NO. 348

HYDRAQUADDER OPERATING LEVERS

Mergenthaler Linotype Company, Brooklyn, N.Y.

June 15, 1961

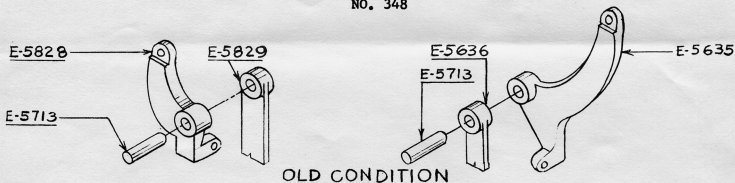
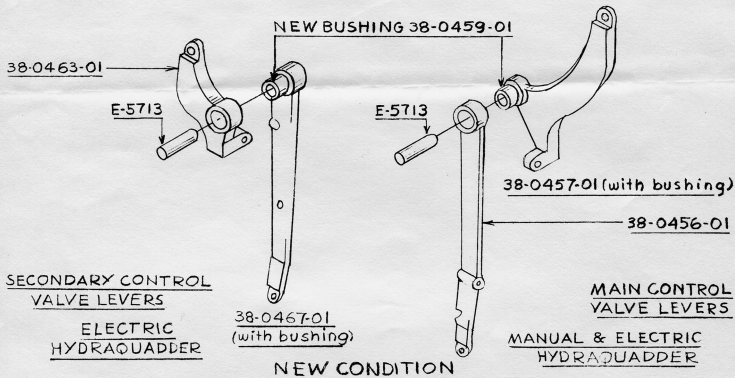
The operating levers which actuate the main and secondary control valve spindles have been redesigned to incorporate an oilite bushing 38-0459-01 to reduce wear of the levers and the studs on which they pivot.

Can be applied to all outstanding Linotypes equipped with Hydraquadder by ordering parts 38-0457-01 and 38-0456-01 for Manual and Electric Hydraquadders, and also parts 38-0467-01 and 38-0463-01 in addition, for an Electric Hydraquadder.
